STATE OF NORTH CAROLINA
DEPARTMENT OF TRANSPORTATION

June 13, 2024

SUBJECT: Environmental Permits for the Improvements to NC 150 in Catawba and Iredell Counties Division 12, **TIP: R-2307.**

Permit Site Changes between 2020 and 2024 Permitting:

**PERMIT DRAWING
SHEET 3 OF 22**

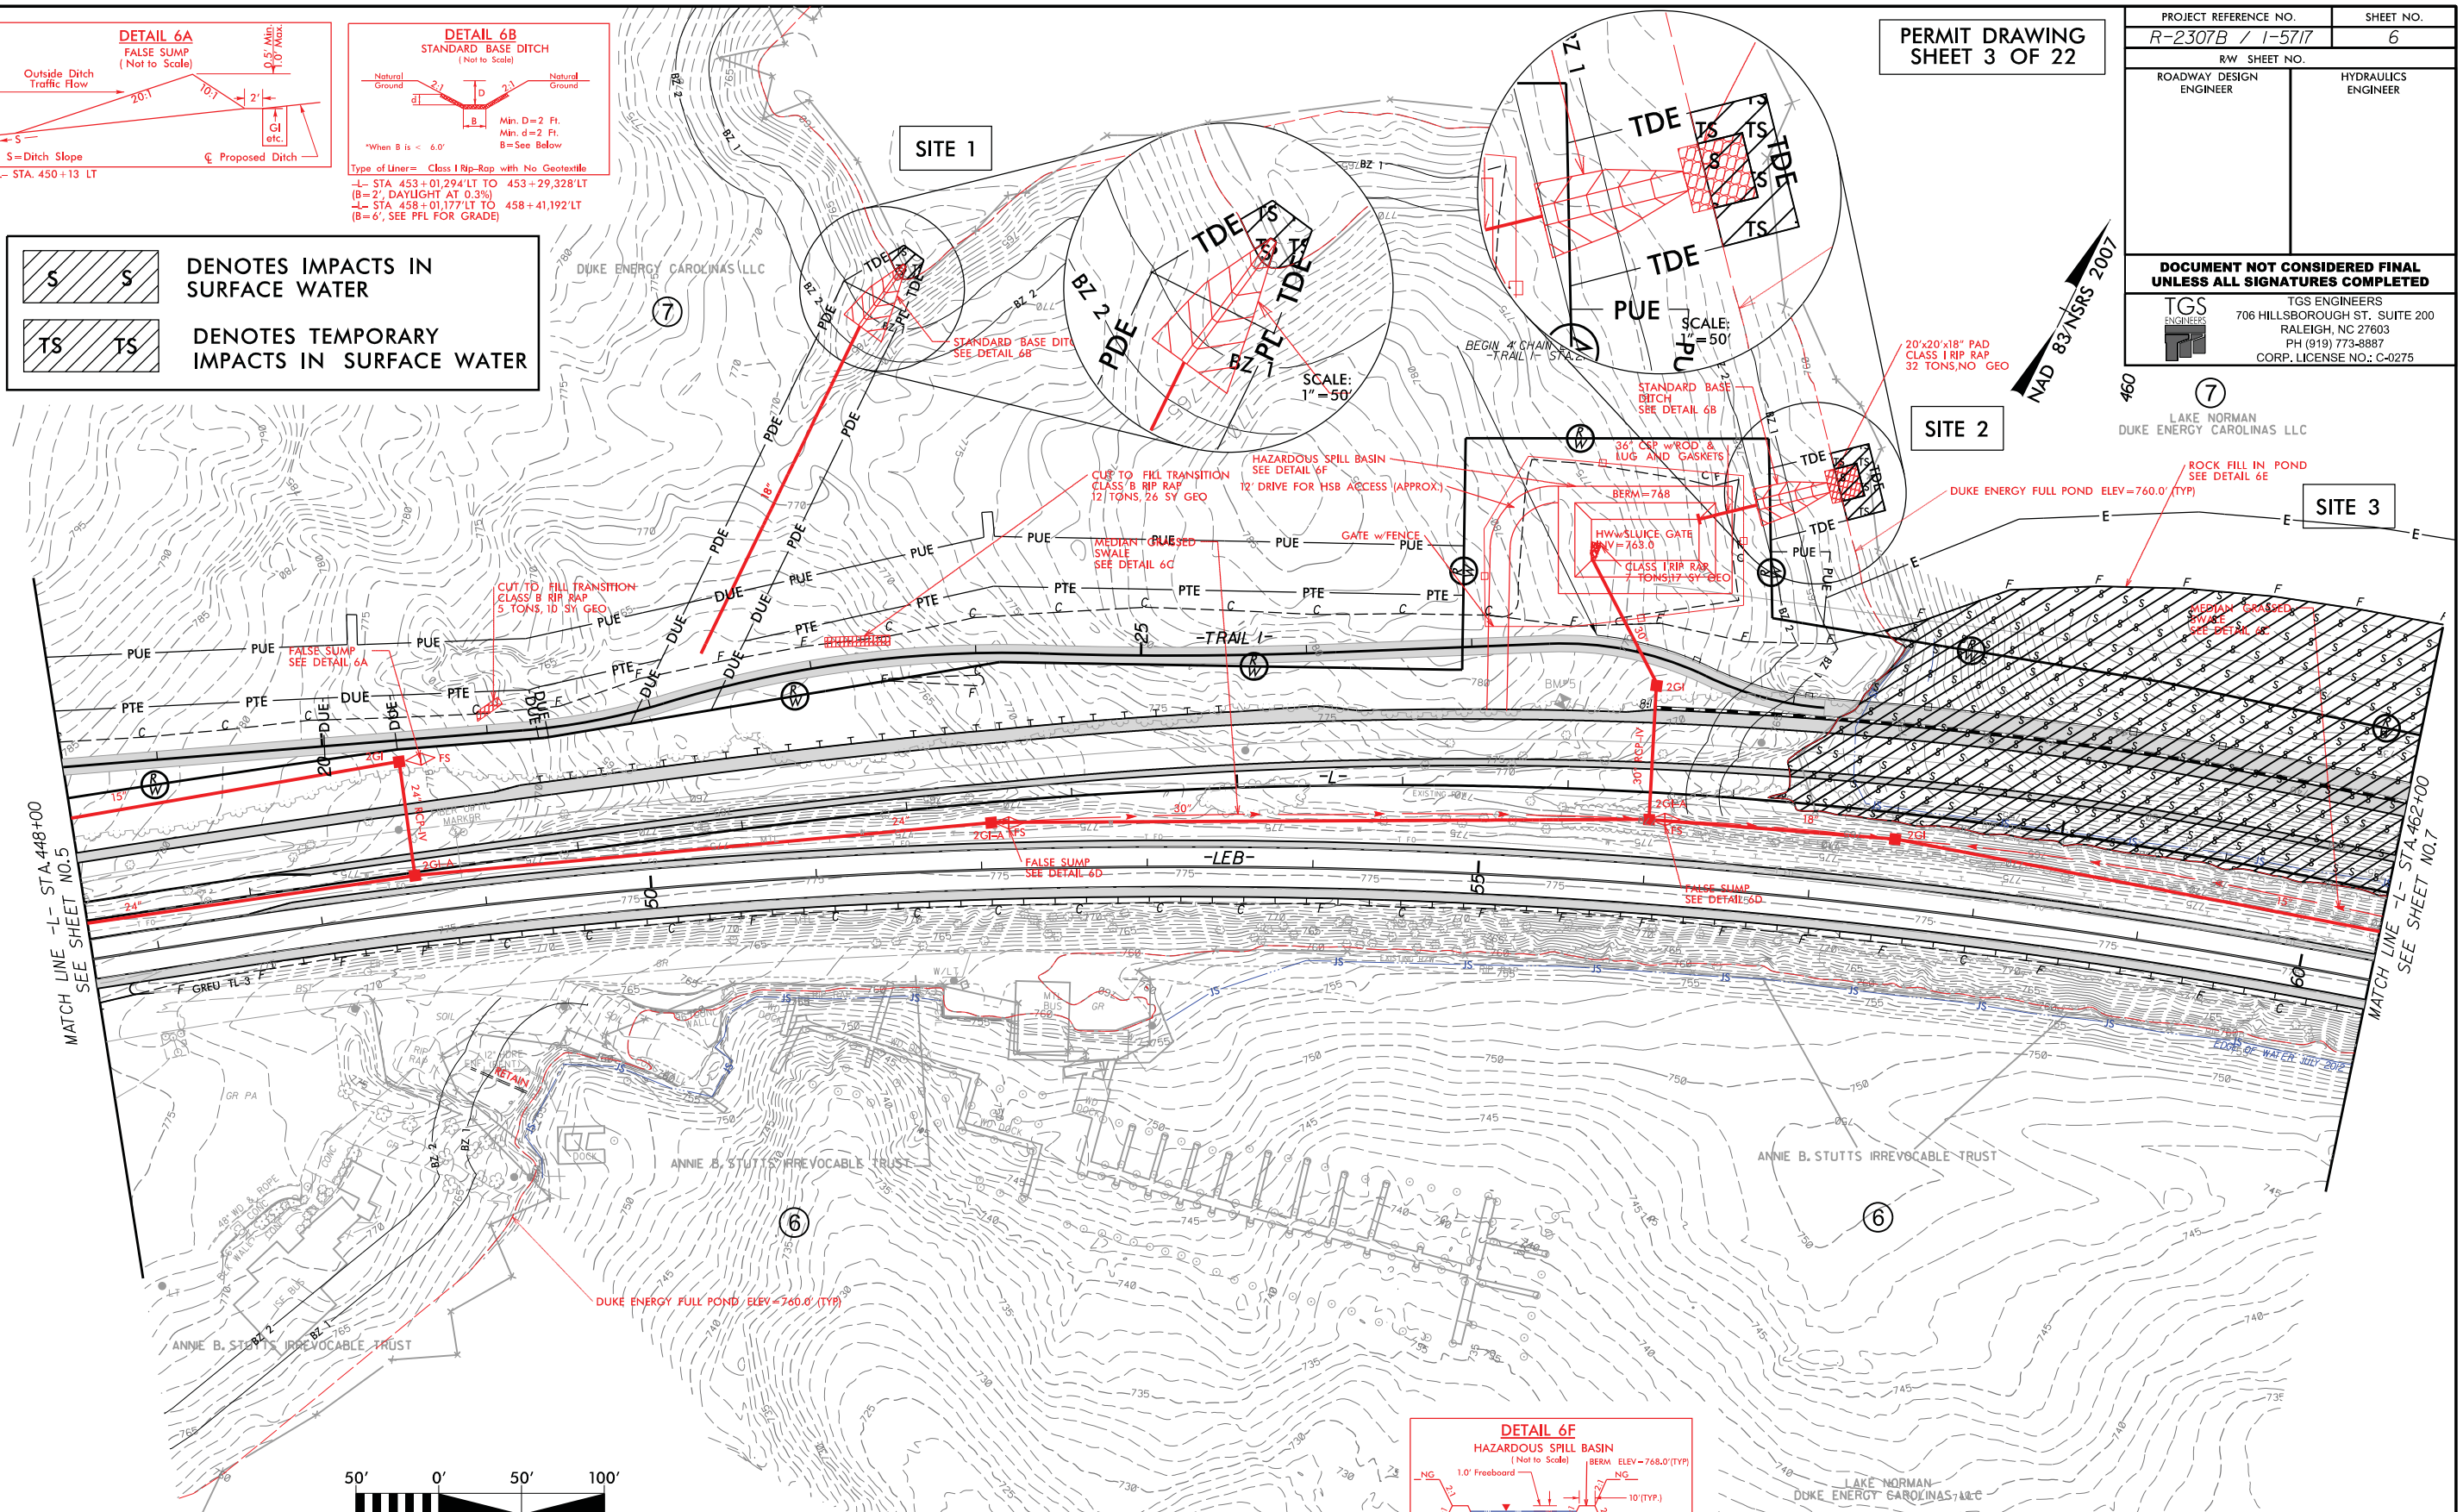
Site 3: Three temporary Surface Water Impacts were added down to elevation 750 ft on Permit Drawing Sheets 2-5. Temporary Surface Water Impacts increased from 0 to 0.070 acre.

PERMIT DRAWING
SHEET 4 OF 22

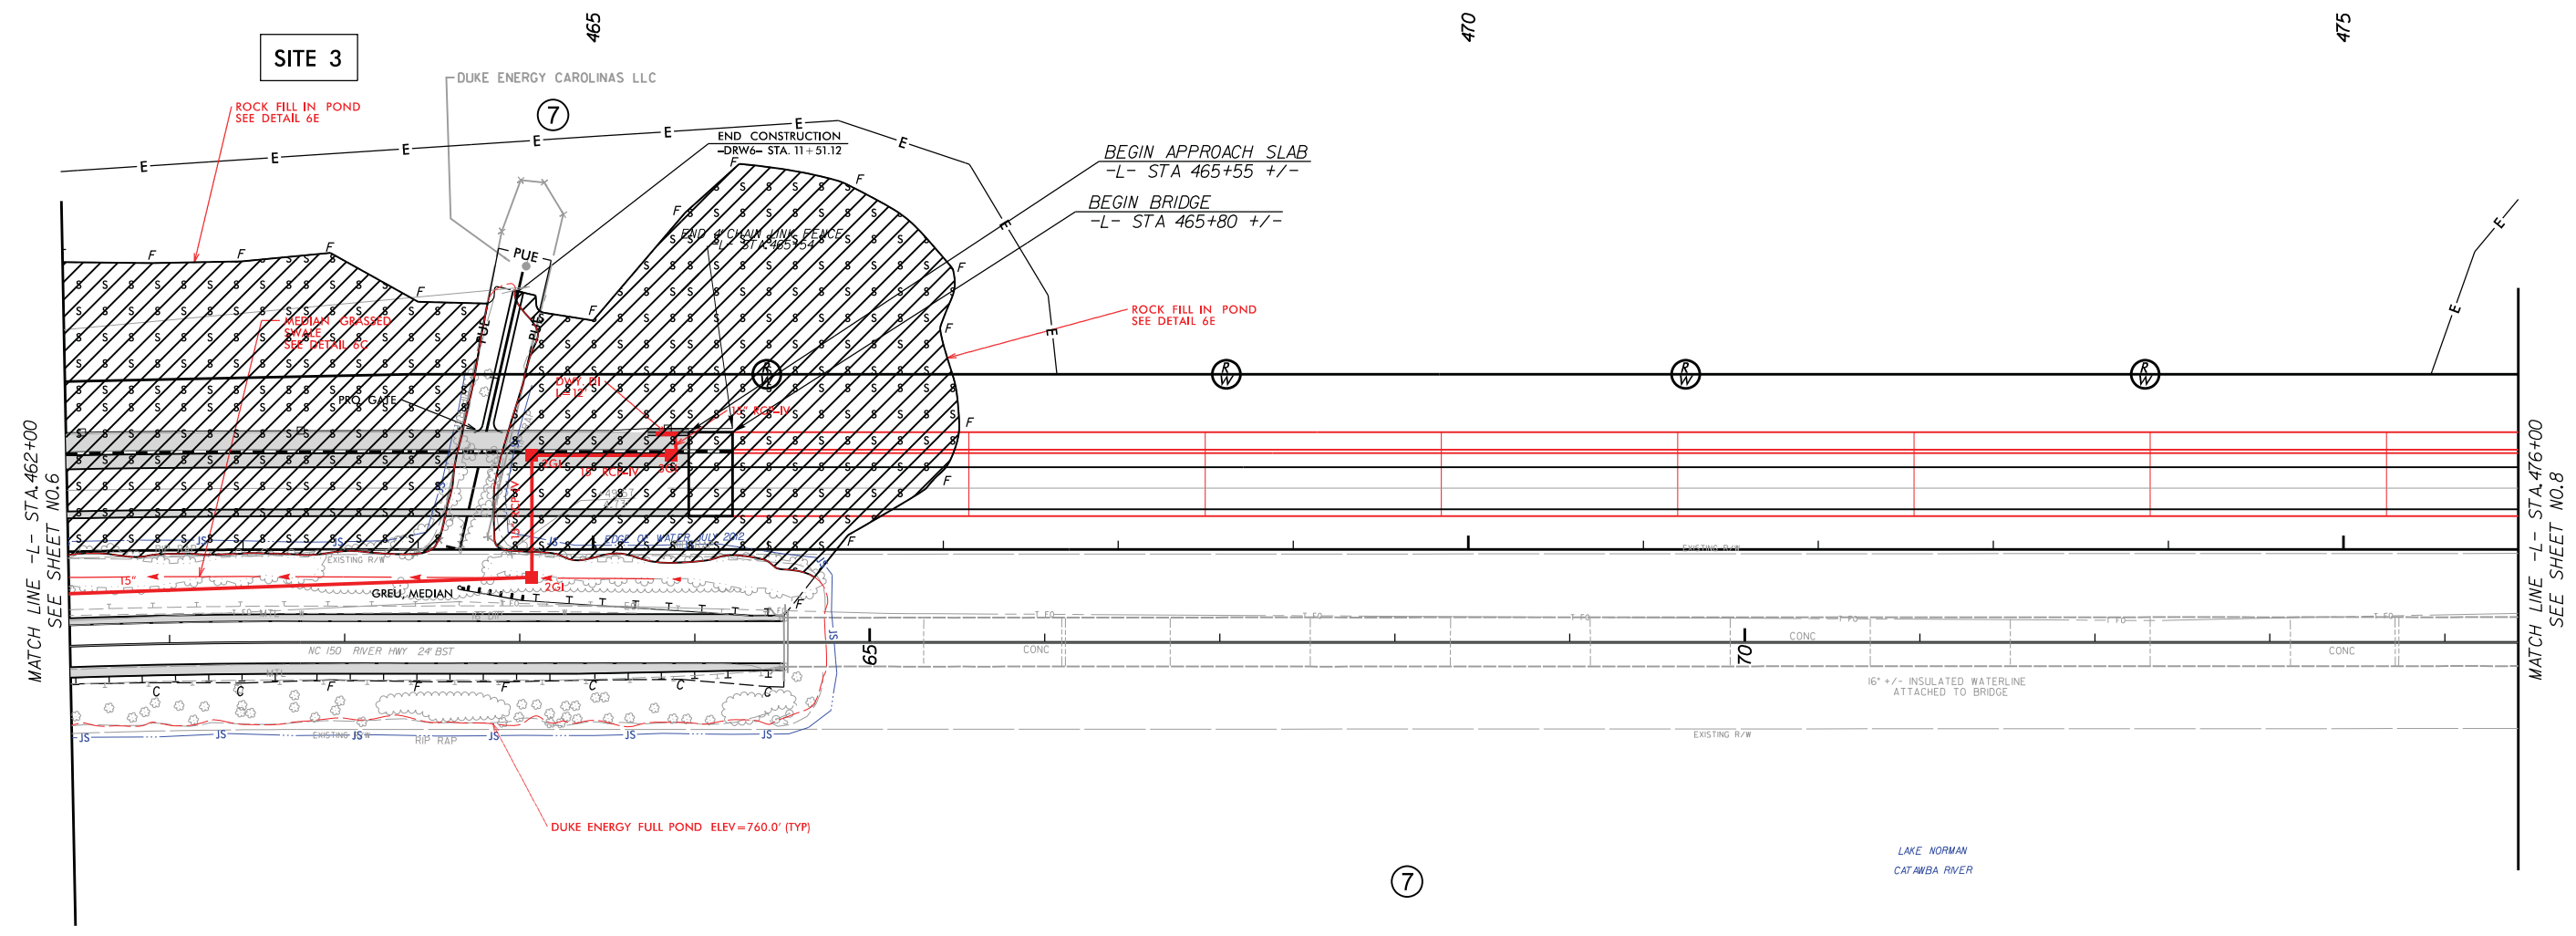
Site 3/ Permit Drawing Sheets 4-6: Due to concerns from Duke Energy regarding boater safety and the alignment of bridge piers with the existing structure, the proposed bridge span arrangement was modified to better match the existing bridge. Permit Drawing Sheets 4-6 and associated footnote on the Impact Summary Sheet were updated.

**PERMIT DRAWING
SHEET 7 OF 22**

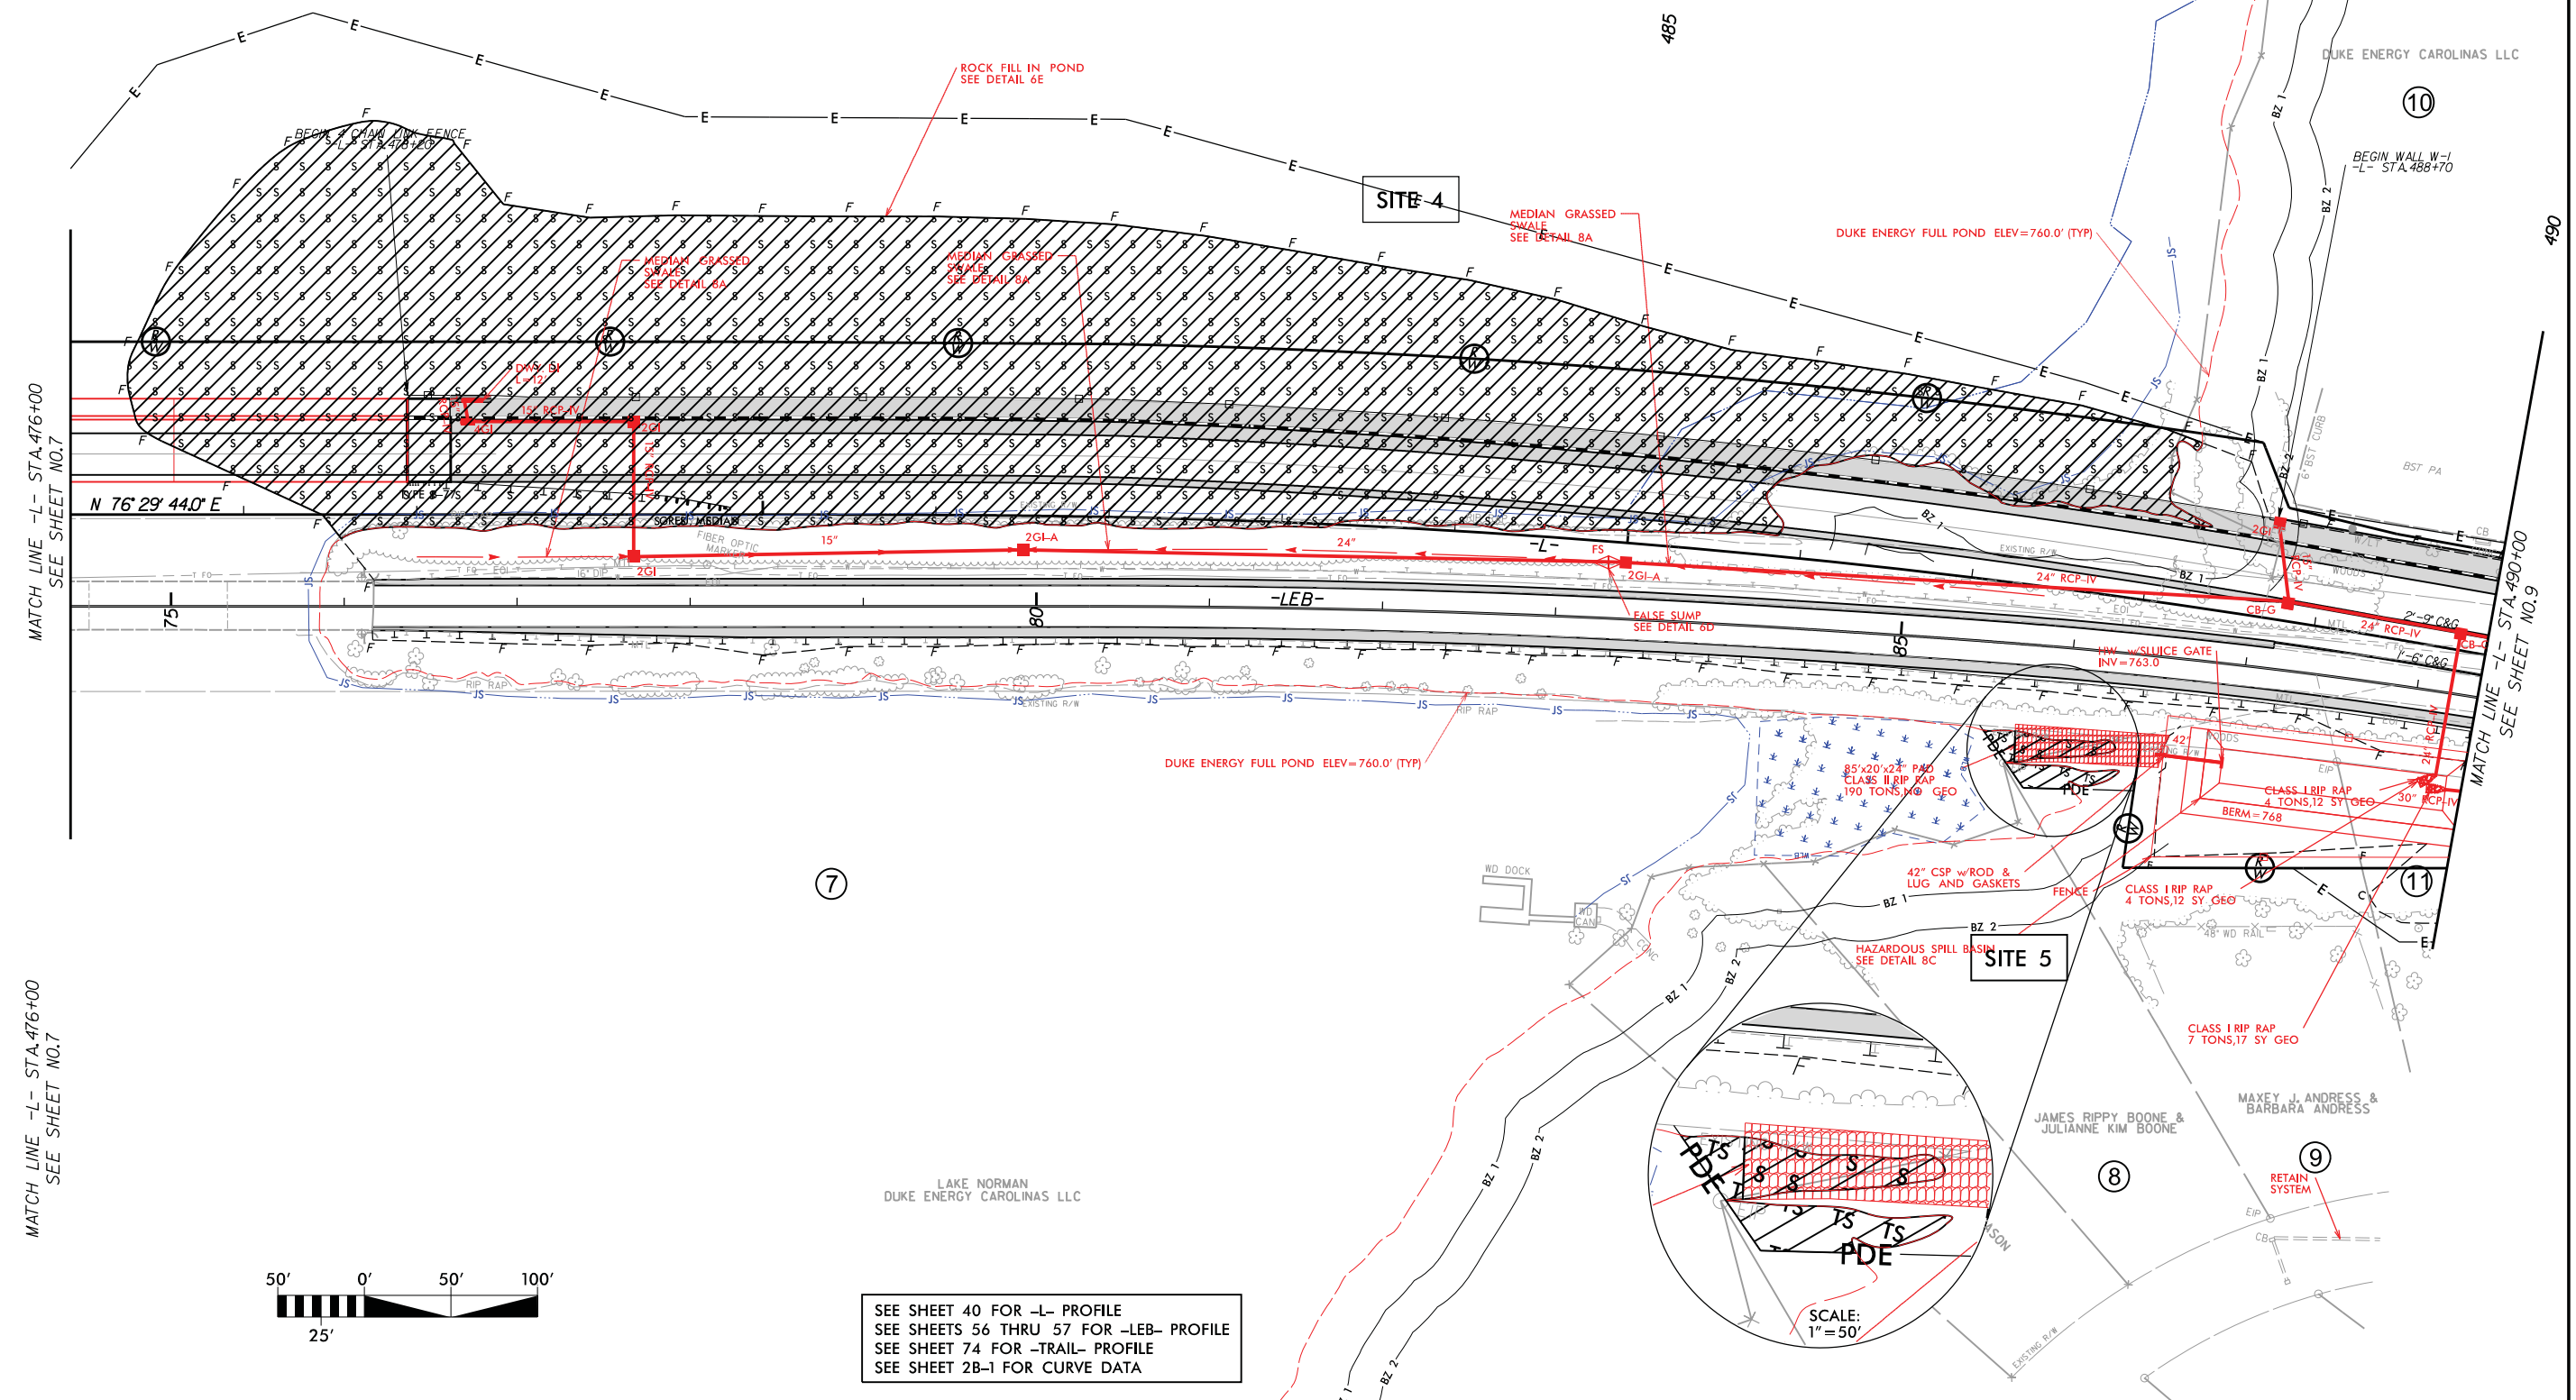
Site 4: Two temporary Surface Water Impacts were added down to elevation 750 ft on Permit Drawing Sheets 7-8. Temporary Surface Water Impacts increased from 0 to 0.162 acre.
